OPTIMIZATION SUPPORT EVALUATION

HAVERTOWN PCP SITE  
HAVERTOWN, PENNSYLVANIA

Report of the Optimization Support Evaluation  
Site Visit Conducted at the Havertown PCP Superfund Site  
August 5, 2003

EPA 542-R-04-033  
March 2004  
[www.epa.gov/tio](http://www.epa.gov/tio)  
[clu-in.org/optimization](http://clu-in.org/optimization)

**FIGURE 1-1. THE HAVERTOWN PCP SITE AND THE SURROUNDING AREA.**

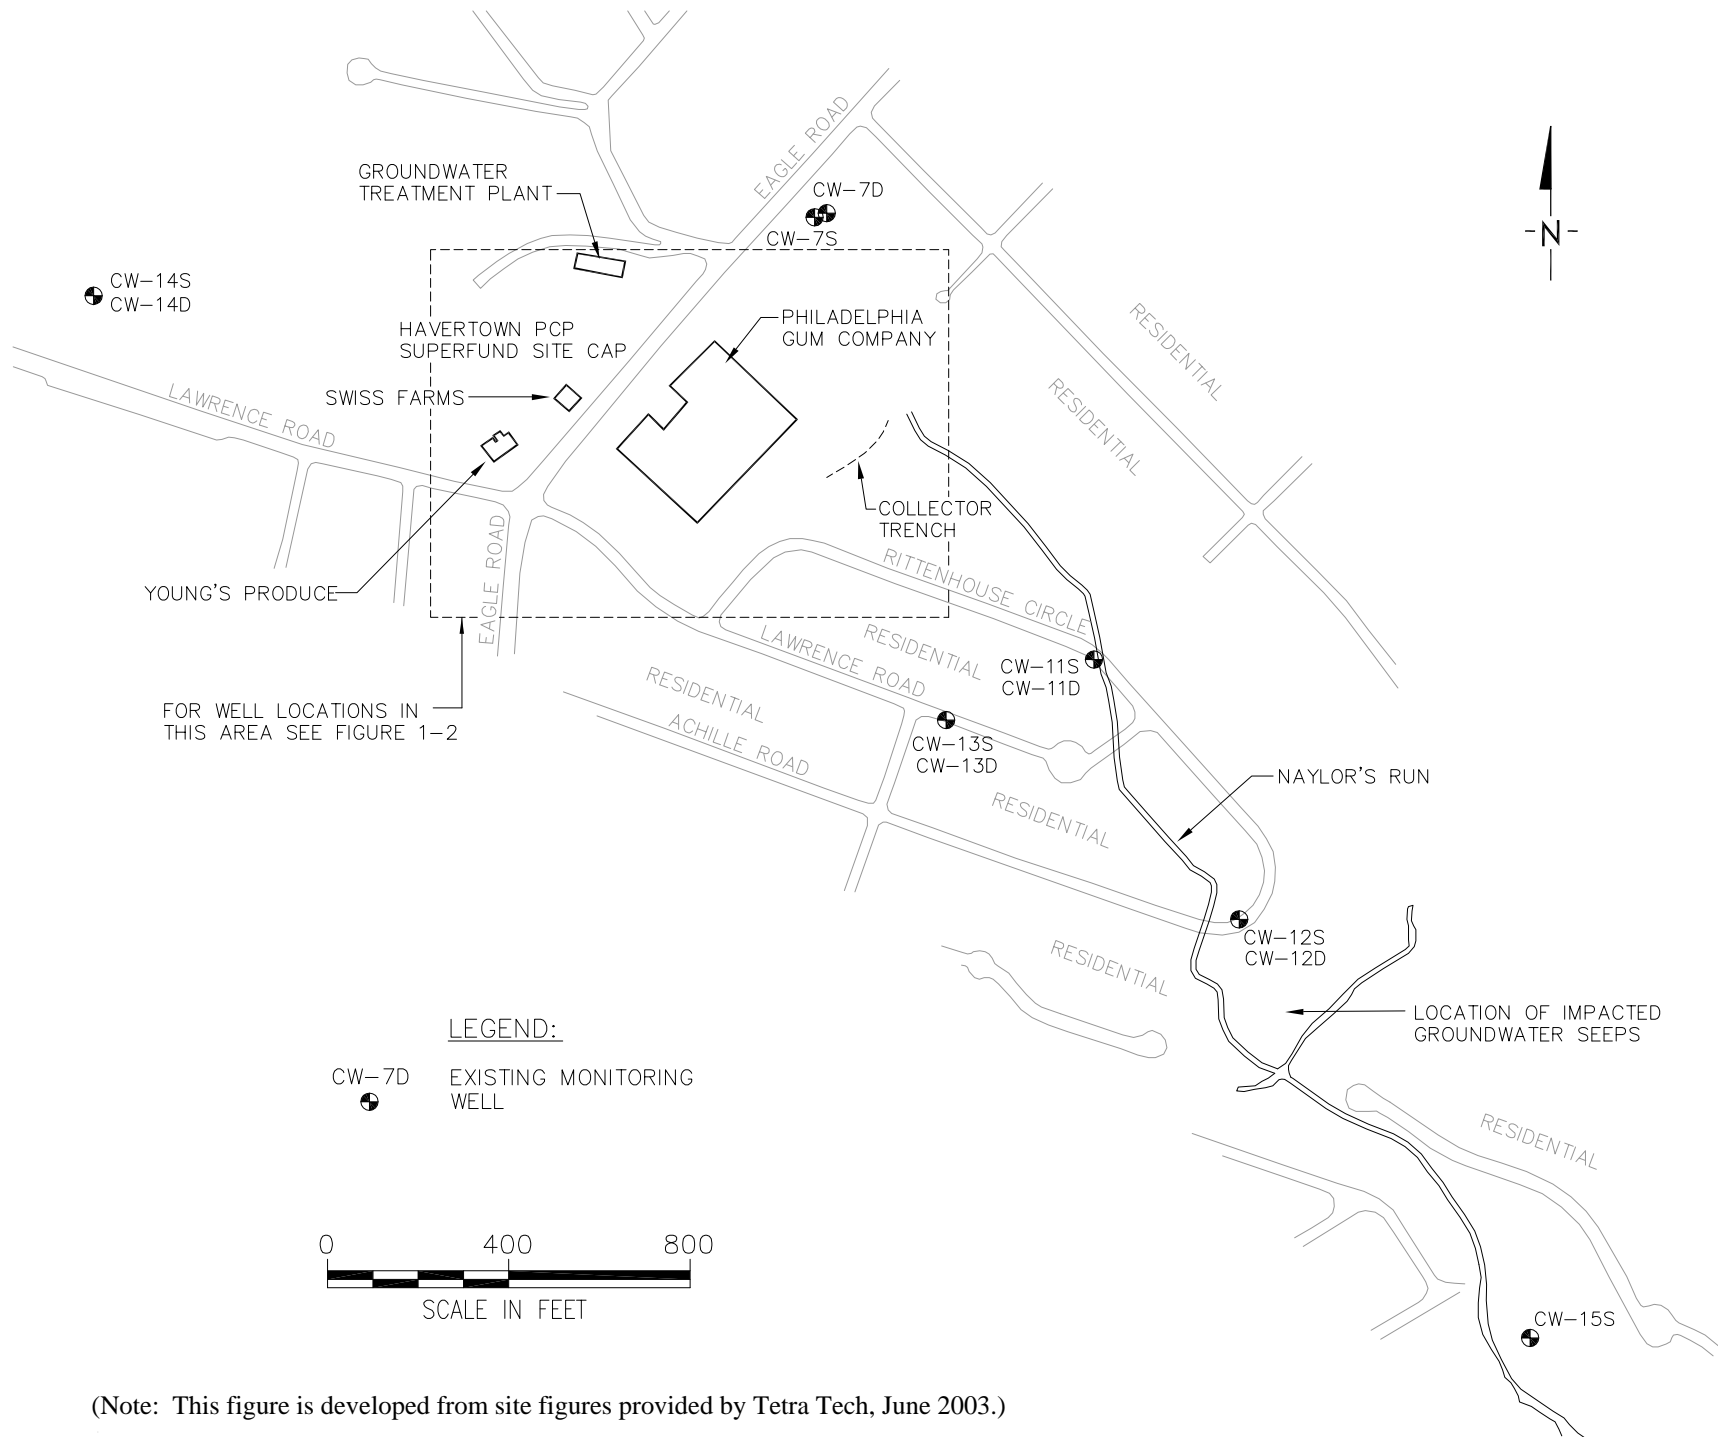
In 1999, the site team identified a contaminated seep adjacent to Naylor's Run (location indicated on Figure 1-1). By the Summer of 2003, the site team found an abandoned 12-inch sewer line that has likely been facilitating the transport of contaminated ground water downgradient and causing the seep. PCP concentrations of over 500 ug/L have been observed at this downgradient location even though upgradient monitoring points (such as the CW-12 cluster) show lower or undetectable concentrations. During the OSE visit, the site team showed the OSE team the seep area where impacted water was surfacing and indicated that addressing this sewer line, seep, and resulting contamination is a top priority.

A primary concern regarding capture is the presence of an abandoned 12-inch sewer line that is likely acting as a conduit for contaminated ground water. This sewer line apparently ends near Naylor's Run in the location of "impacted seeps" indicated on Figure 1-1.

Conditions in Naylor's Run have improved substantially due to the operation of the OU2 interim remedy; however, portions of Naylor's Run still have substantial impacts likely due to a 12-inch sewer line providing a conduit for contaminated ground water to reach the surface and discharge into Naylor's Run. Seep concentrations of PCP have been as high as 750 ug/L and sediment PCP concentrations have been as high as 6,200 ug/kg. Dioxin concentrations are also elevated. This area is indicated on Figure 1-1.

- The site team should continue with their efforts to investigate and properly seal the abandoned sewer line that has allowed contaminated ground water to migrate downgradient and then surface as a seep in a residential area. The site team should make this effort and the remediation of the associated soils and sediments their first priority.

**FIGURE 1-3. EXTENT OF PCP CONTAMINATION IN THE SHALLOW ZONE (APPROXIMATELY 5 TO 20 FEET BGS).**

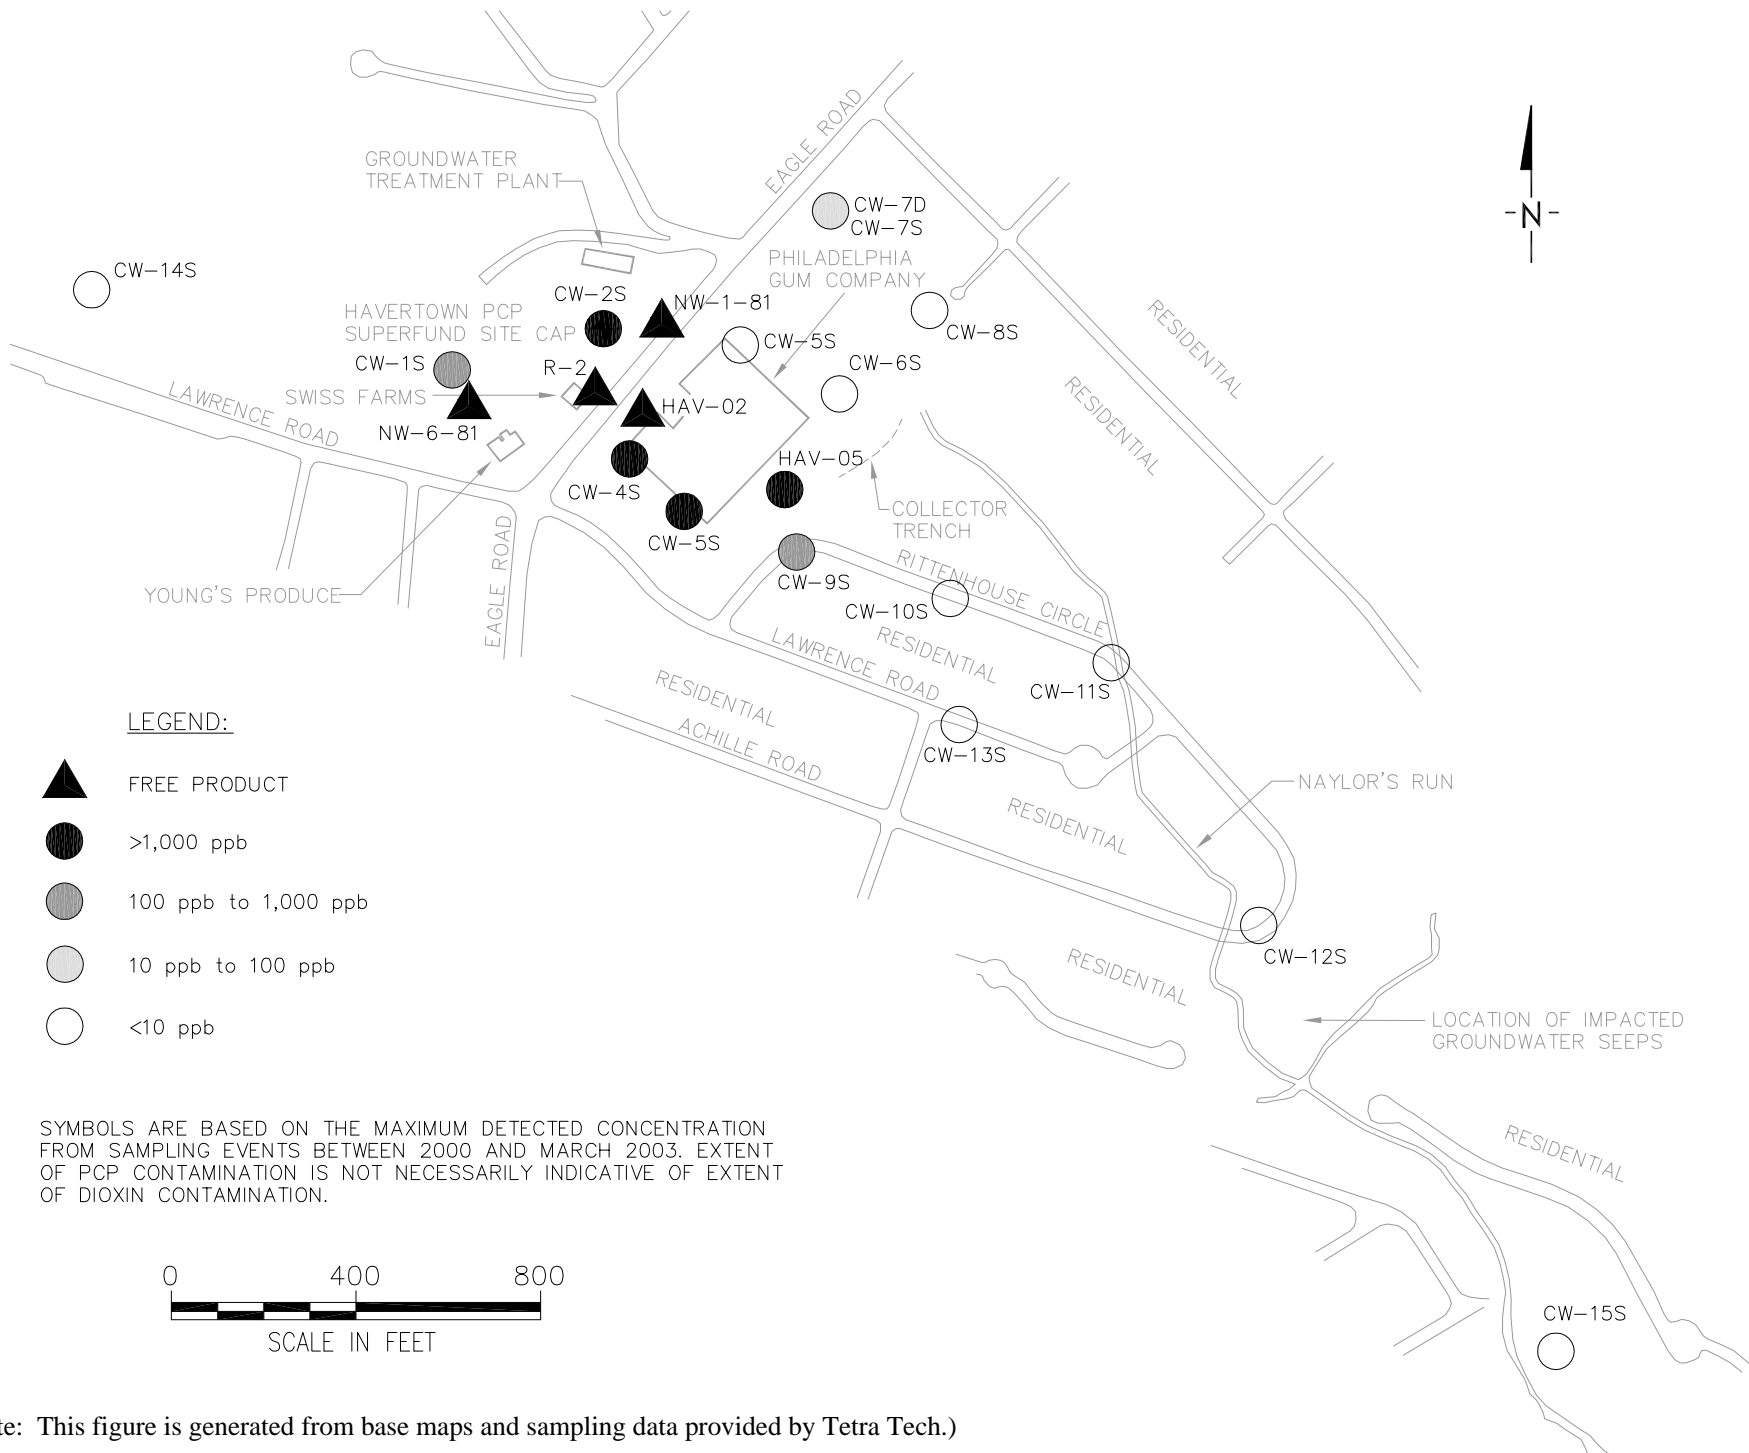
Figure 1-3 shows the extent of PCP contamination near the NWP and PCG properties in the shallow aquifer (overburden), and Figure 1-4 shows the extent of PCP contamination in the same area for a deeper aquifer interval (fractured bedrock). The highest detected levels of PCP at the time of the OSE are 13,000 ug/L in R-2, 30,000 ug/L in HAV-02, and 8,700 ug/L in HAV-04 (March 2003 sampling

The ground water sampling is also relatively incomplete in terms of delineating the plume, particularly to the south and in the vertical direction. The wells in the CW-4 and CW-5 clusters are the southern most wells near Eagle Road, and as shown in Figures 1-3 and 1-4, the PCP concentrations at these wells exceed 1,000 ug/L. With no additional wells to the south, the PCP plume is not delineated. This lack of delineation affects the preliminary capture zone analysis conducted above because the degree of capture cannot be determined without full delineation. As depicted in Figure 1-4, a number of deep wells with screened intervals down to approximately 50 feet below ground surface have concentrations exceeding 1,000 ug/L. Without deeper wells, the PCP plume cannot be considered delineated vertically. In EW-1 through EW-3 (extraction wells located upgradient of the collector drain that have never been used for pumping), the concentrations are also above 1,000 ug/L. These wells are screened from approximately 40 to 80 feet bgs, whereas the collector drain is completed to approximately 16 feet bgs. With this relatively long screened interval, the vertical extent of contamination cannot be determined. The contamination may only be present near the tops of these relatively long screened intervals, but it may also be present at deeper levels. In addition, these wells may be acting as conduits, allowing contamination at approximately 40 feet to migrate to depths near 80 feet. The upward gradient in this area due to the operation of the collector drain makes this downward migration unlikely, but this possibility should not be eliminated without deeper sampling.

- Further delineation of the contaminant plume is suggested, especially to the south and at depth. Locations and depths for seven new monitoring wells are proposed.
- Once the plume is delineated, a target capture zone should be determined and the site team should conduct a thorough capture zone analysis. A preliminary analysis has been conducted as part of this report and is provided in Section 4.2.2.
- Modifications should be made to O&M practices to reduce system downtime. Foremost among the suggested items is to bypass one or two of the UV/Oxidation units.

**FIGURE 4-1. POTENTIOMETRIC SURFACE FOR SHALLOW GROUNDWATER UNDER PUMPING CONDITIONS (APPROXIMATELY 5 TO 20 FEET BGS).**

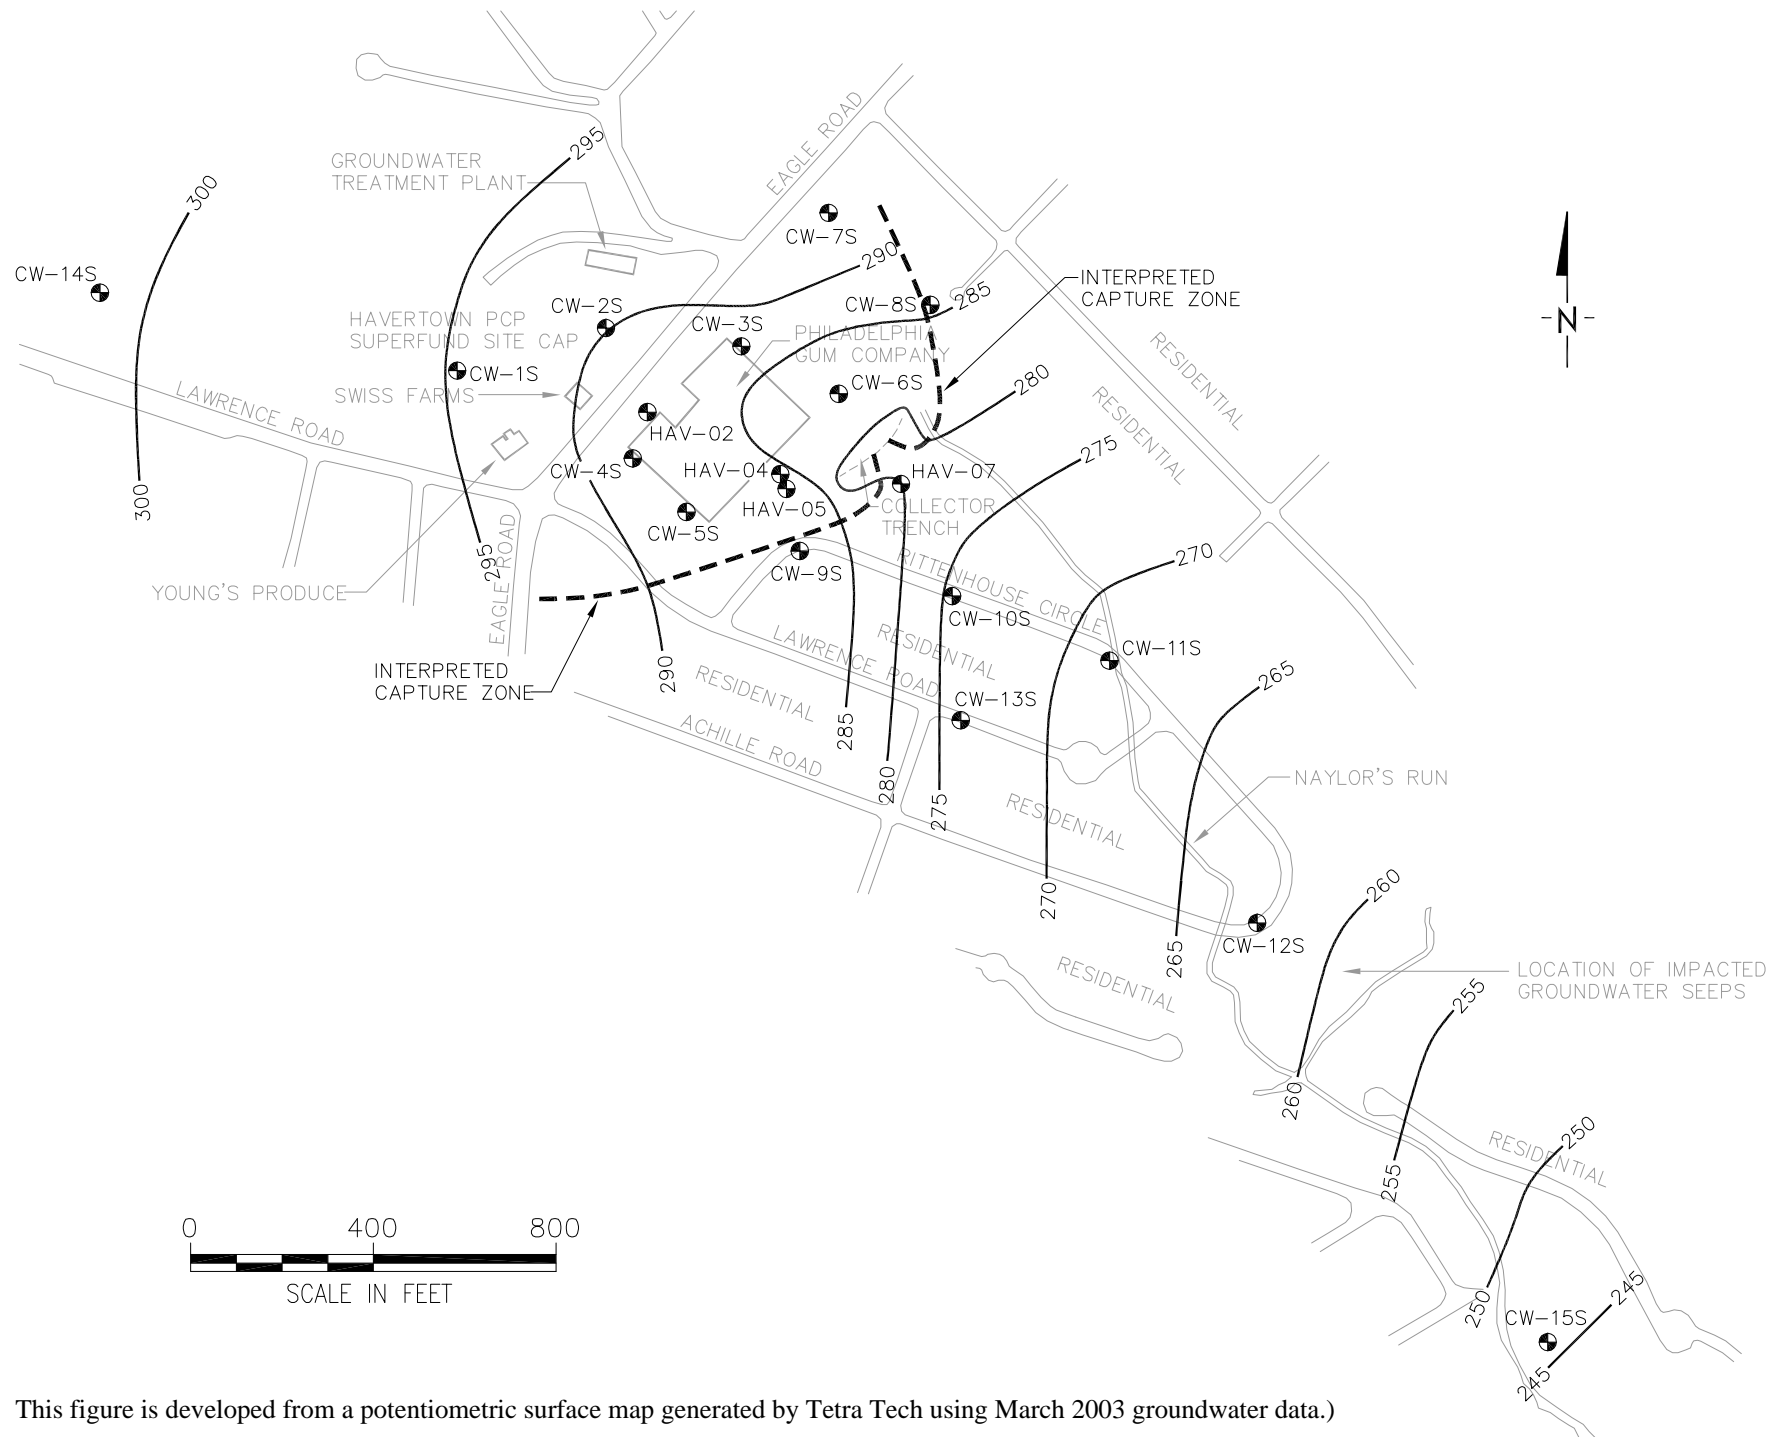
Water levels collected in both the shallow zone (overburden) and deep zone (bedrock) in March 2003 have been used by the site team to generate potentiometric surface maps. These maps are presented in Figures 4-1 and 4-2. Approximately 29 measurement points are used to generate the shallow potentiometric surface map, and approximately 14 measurement points are used to generate the deep potentiometric surface map. Both figures show ground water flow to the southeast, and both figures show the influence of the collector drain. As expected, the influence of the collector drain in the shallow zone is more predominant than the influence in the deeper zone. This is partially due to the use of water level measurement points within the drain when generating the shallow potentiometric surface. Nevertheless, the influence of the drain on the deeper water level measurements suggests that, under pumping conditions, some water in the deeper aquifer is entrained by the drain. These two figures, when compared with each other, can be used to interpret vertical ground water flow, but no easily discernible trend is recognized.

As part of this report, the OSE team has used the March 2003 potentiometric surface maps generated by the site team to interpret the horizontal capture in both the shallow and deep zones. The interpreted areas of capture are depicted in Figures 4-1 and 4-2, with the shallow capture zone more extensive than the deeper capture zone. Therefore, ground water that flows up from within the deeper capture zone should be within the shallower capture zone. These preliminary analyses consider only one round of water levels and do not rigorously consider vertical flow. Because water levels may change seasonally affecting both horizontal and vertical flow, a more thorough capture zone analysis is merited.
